**CITY OF CHARLOTTESVILLE
BOARD OF ARCHITECTURAL REVIEW
STAFF REPORT
December 15, 2015**

BAR 15-10-04

200 West Main Street

Change to approve new materials

CANOPY DRIP EDGE DETAIL VIOLET CROWN
2015.11.12 14059.00

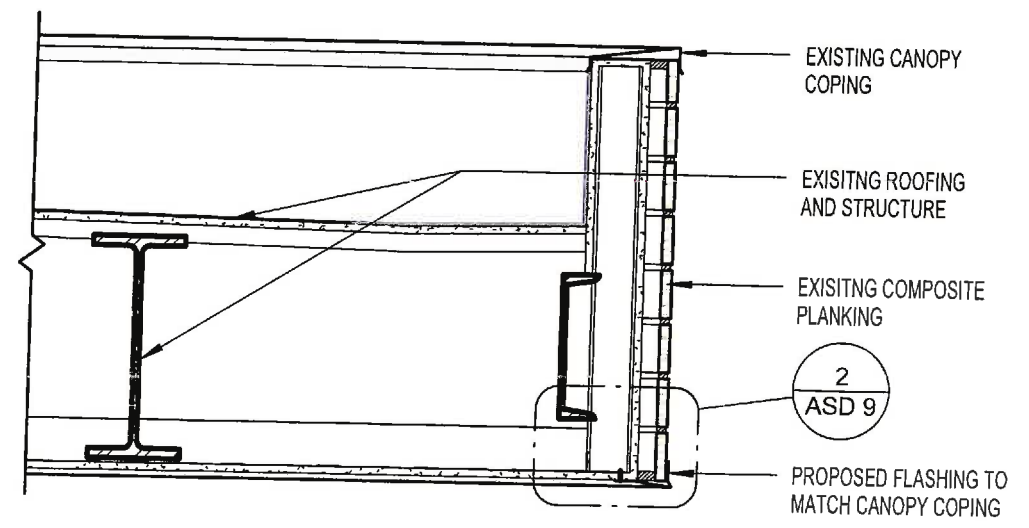
- 2. The marquee scale issue has been addressed with the added trim.**
- 3. The applicant’s argument that the building code requires darkly tinted glass is incorrect because this addition is considered a rehabilitation rather than new construction , according to the Building Code Official, so is not subject to the 2009 Energy Code. Staff has provided the architect with specific examples of clear glass products that may be appropriate. The applicant should replace the tinted glass with clear glass per the ADC District Design Guidelines.**

Added a drip edge to the bottom of the canopy to match the coping that runs along the top profile. Refer to exhibit ASD-9 for details.

- the additional trim on the Marquee to address scale issues;
- the additional 4 movie posters to the left of the entrance door and the moved mechanical equipment box;
- the transom on the east side of the building to match the door height transom on the front.
